**Brighton
Council**

Your Ref: DA 2025/095
Our Ref: 25.133

PLANNING APPLICATION DA 2025/00095 – RESPONSE TO REQUEST FOR ADDITIONAL INFORMATION

PROJECT: CONCRETE BATCHING PLANT
AT: 1 / 13 CROOKED BILLET DRIVE
BRIDGEWATER
FOR: HAZELL BROS GROUP PTY LTD

DRAWING: CIVIL WORKS
EROSION AND SEDIMENT
CONTROL PLAN

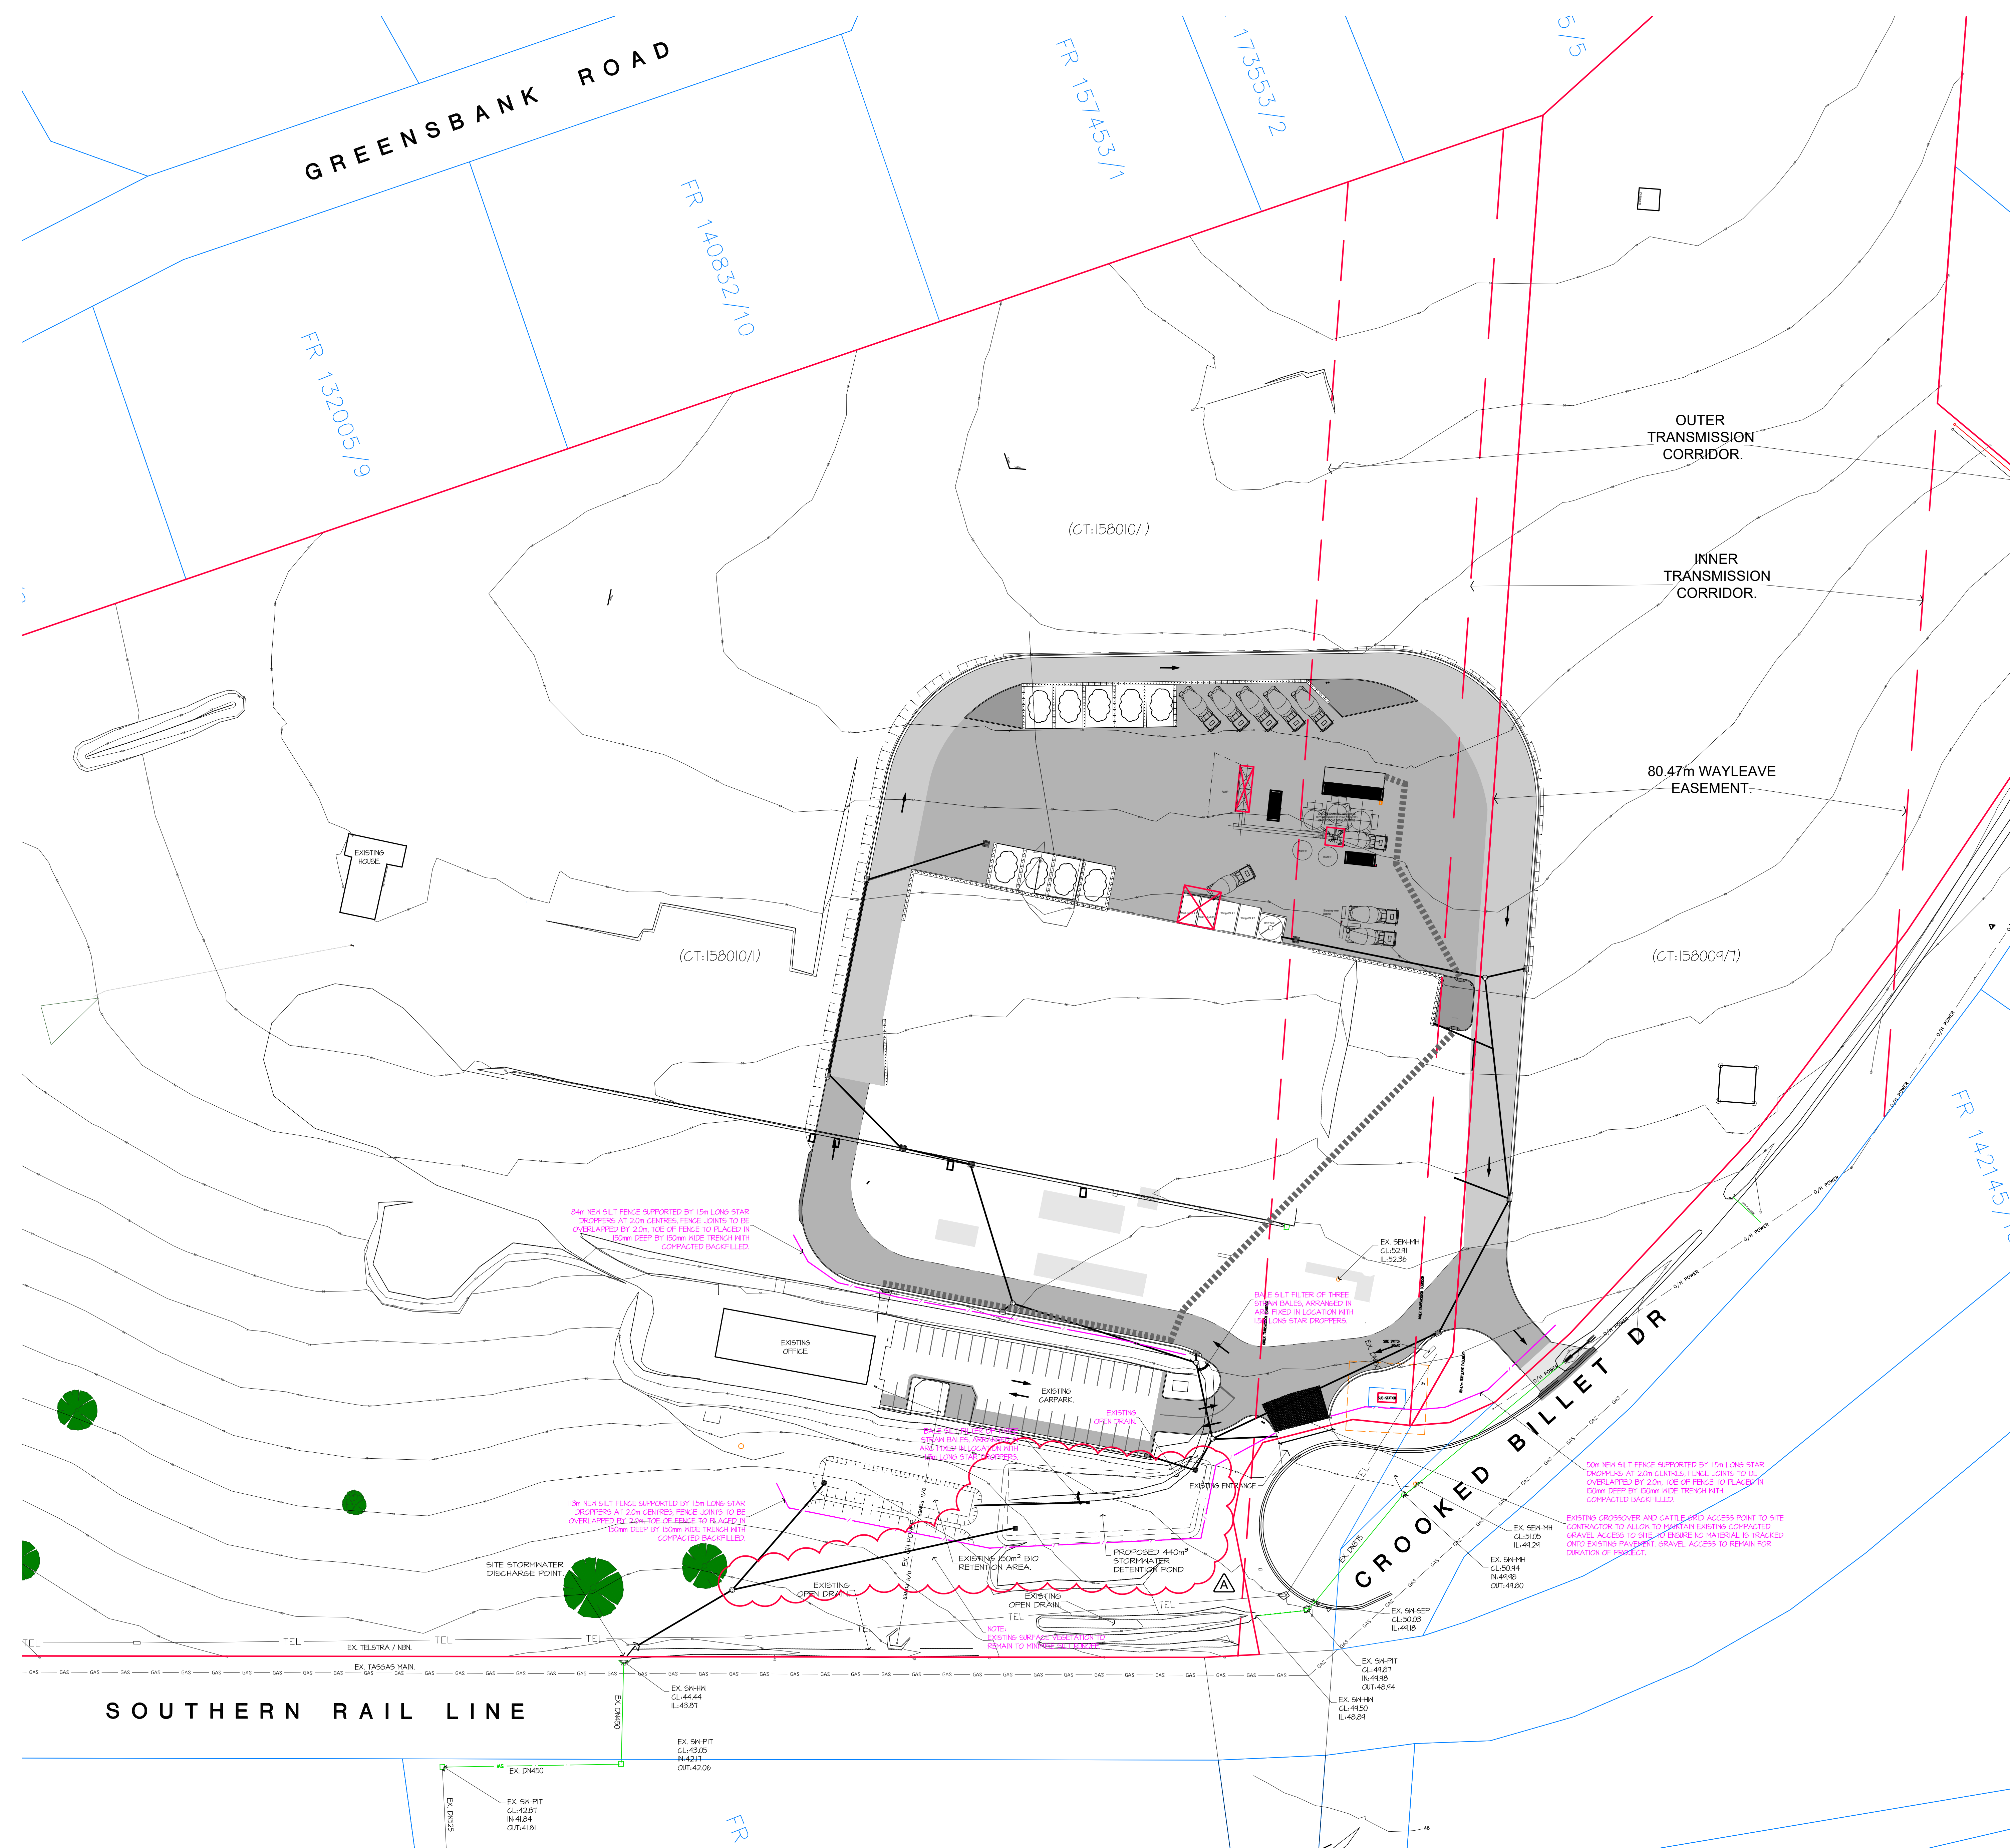
- The Stormwater Management Plan (SWMP) and relevant proposal site plans have been amended in response to these matters, including the issues raised by TasRail. The relevant amended documents include:

- Erosion and Sediment Control Plan, Prepared by 6ty°, Drawing No. CP16, Revision A, Dated 25 August 2025.
- Of particular note, the proposal seeks to maintain the existing stormwater discharge point, located midway along the site's southern boundary, where receiving infrastructure – a culvert beneath the adjoining rail corridor – currently exists. However, the amended Stormwater Management Plan includes updated modelling based on a 1% AEP storm event and has sized the proposed detention pond accordingly.

- The proposed detention pond shown on the amended proposal site plans has a capacity of 440m³, rather than the 153m³ indicated in the SWMP. This increased capacity is intended to accommodate runoff from both the proposed concrete batching plant (subject to the current application) and the separately proposed asphalt plant at the site.

DRAWING: CIVIL WORKS
SAMPLE TURN PATHS
SHEET 2.

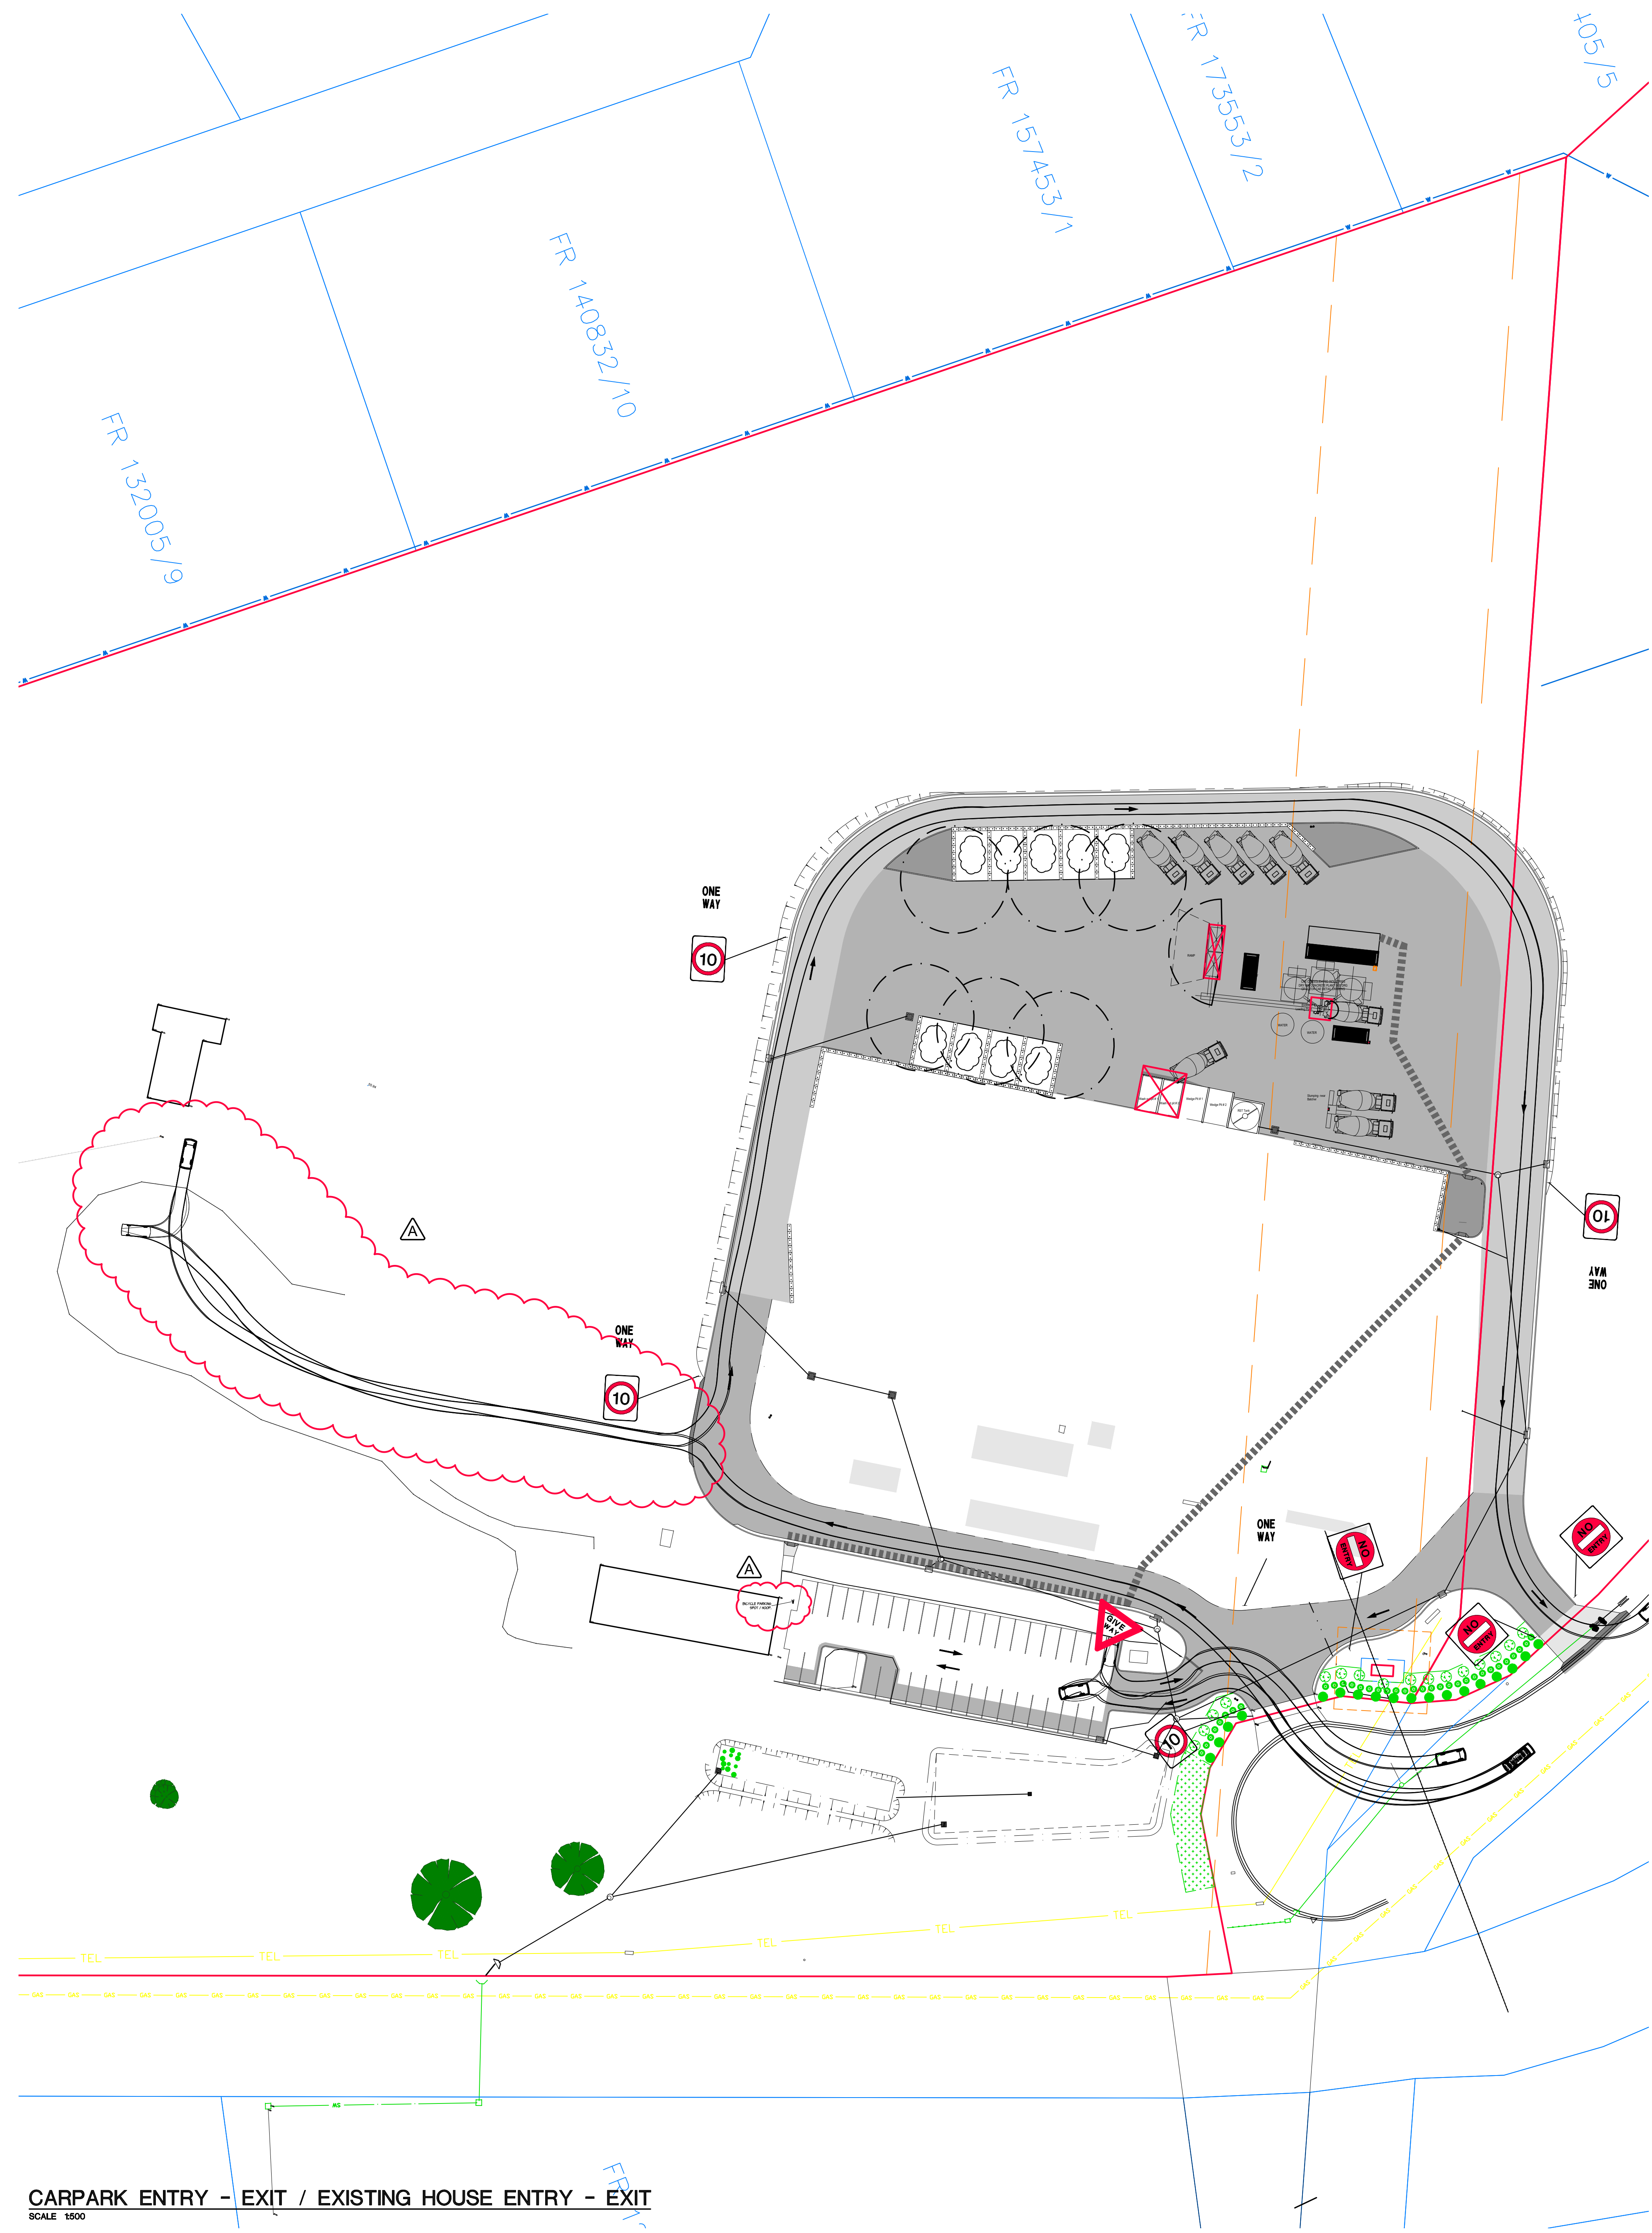
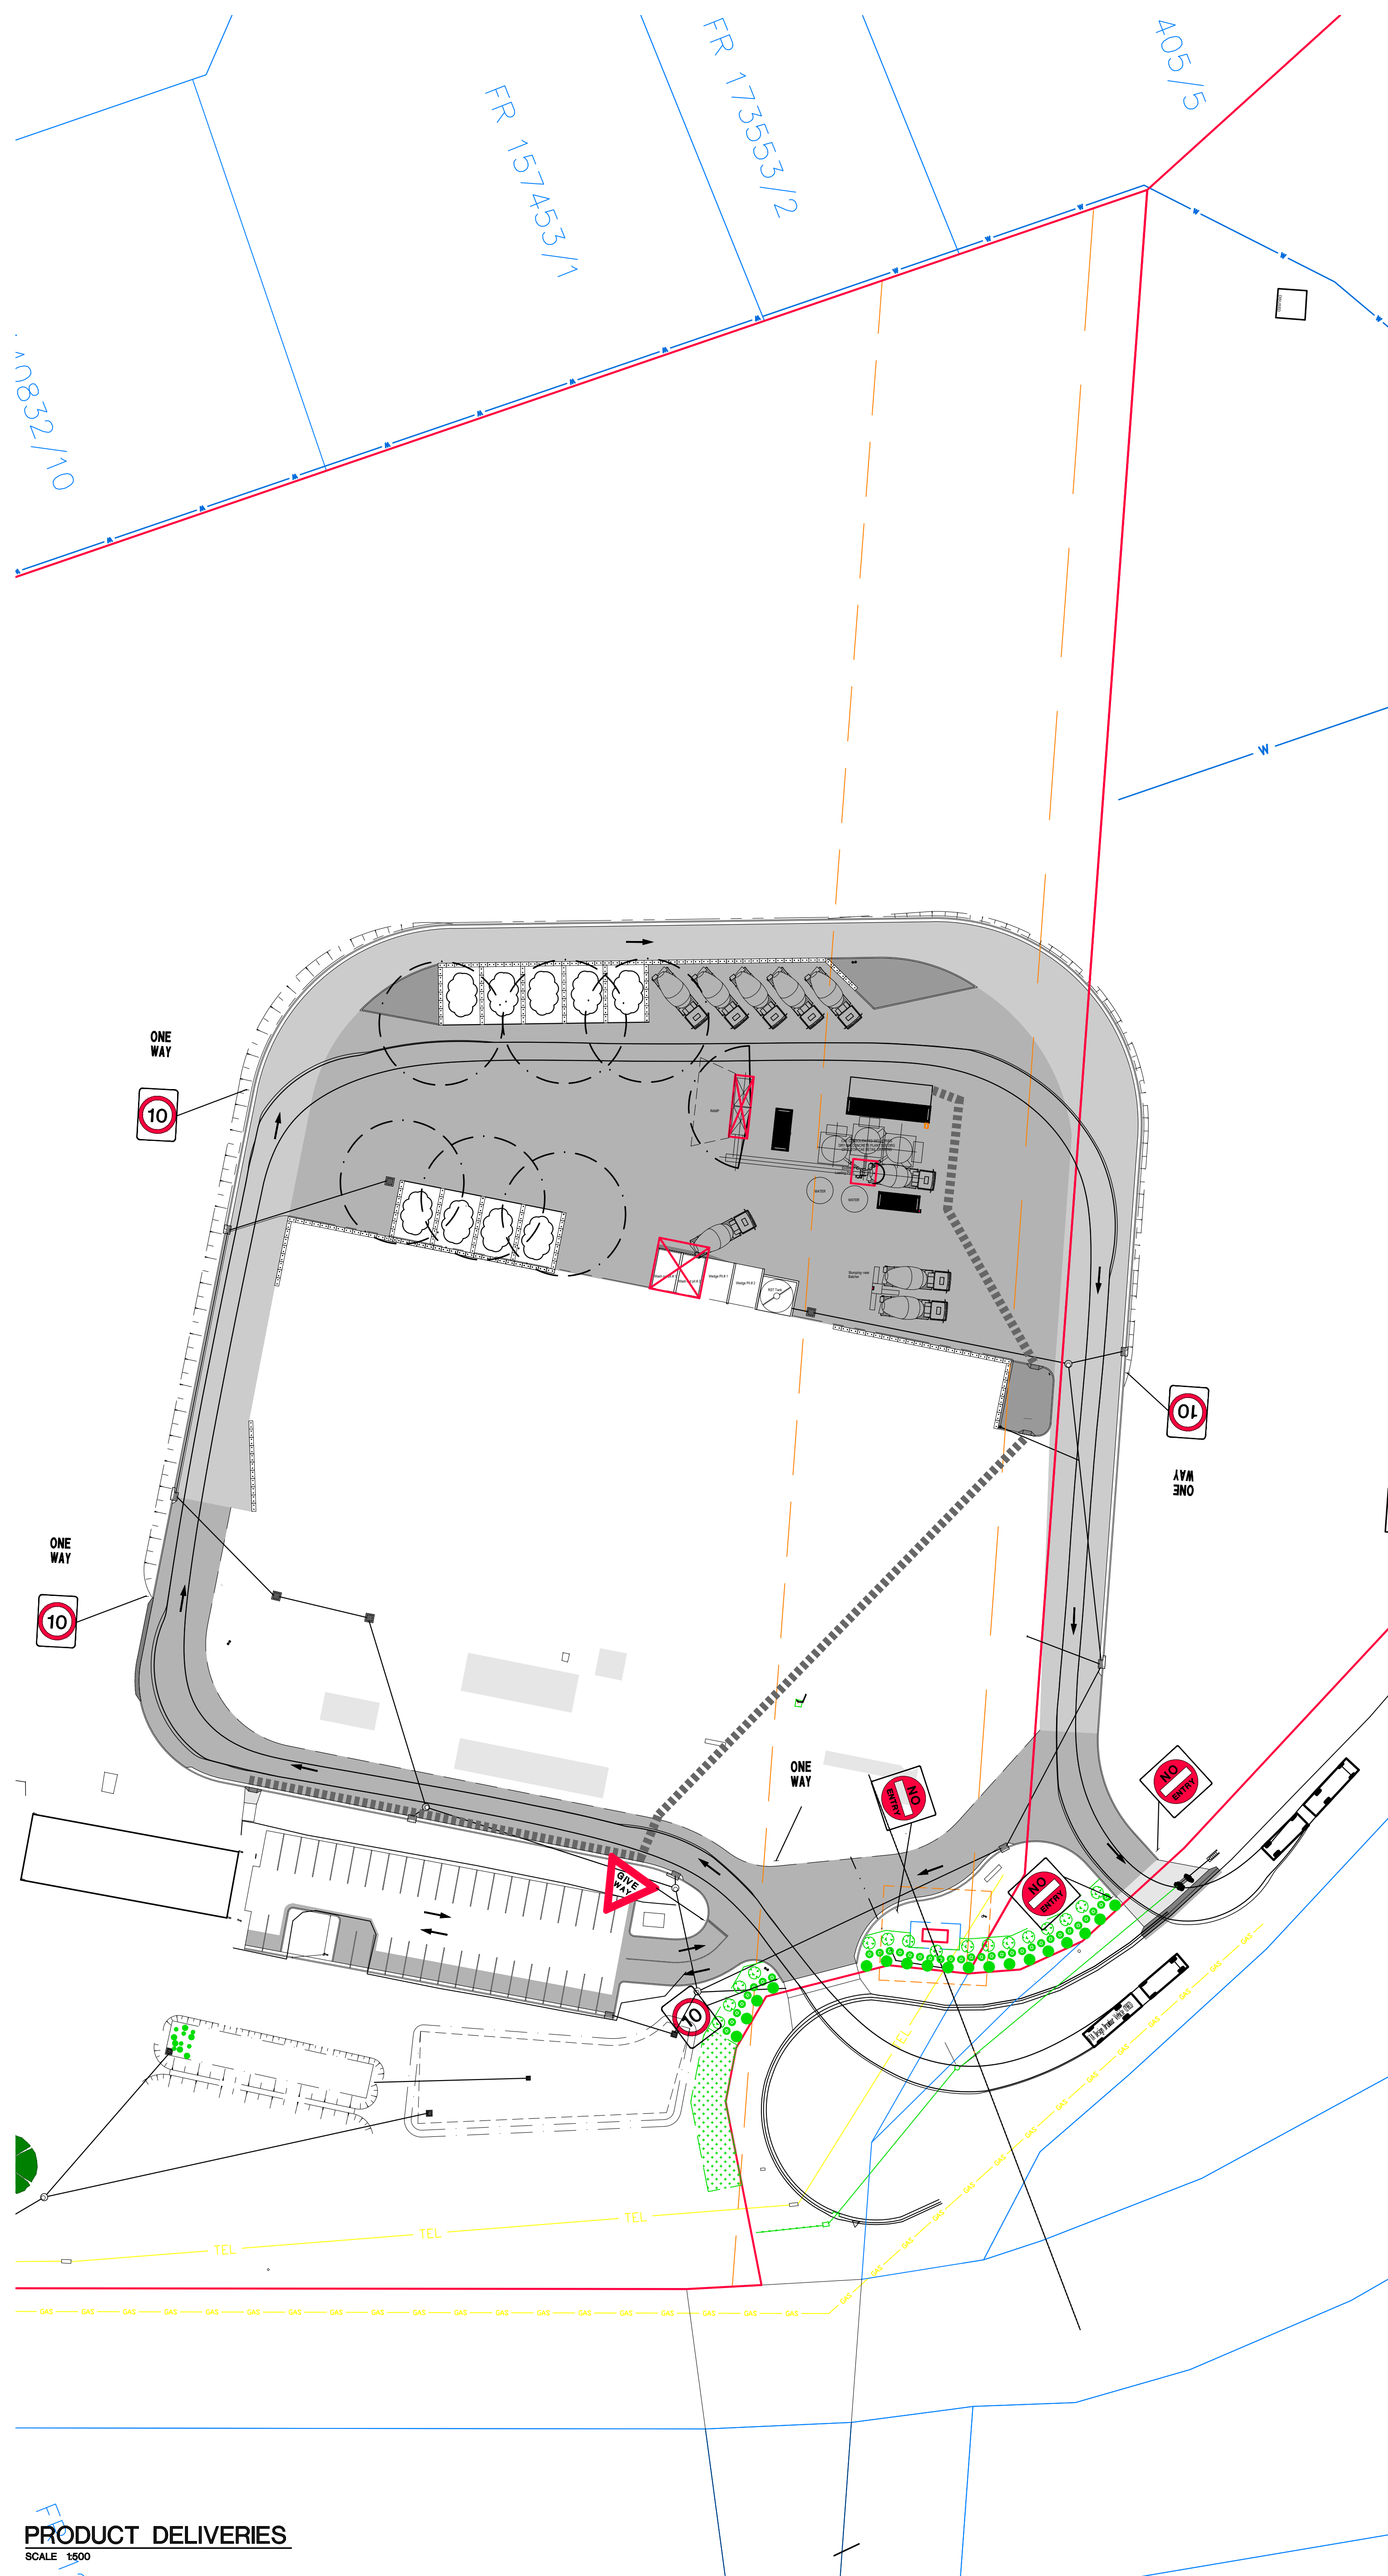
- The following relevant documents accompany this response:
 - Sample Turn Paths Sheet 2, Prepared by 6ty°, Drawing No. CP19, Revision A, Dated 25 July 2025; and
 - Amended Traffic Impact Statement (TIS), Prepared by Traffic & Civil Services, dated 1 August 2025.

The amended plan shows a bicycle parking space as required by the acceptable solution for the relevant code standard. The amended TIS references the location of this parking space.

- The amended Sample Turn Paths Sheet 2 considers the circulation of vehicles associated with the existing dwelling through the site, and this is reflected in the amended TIS.
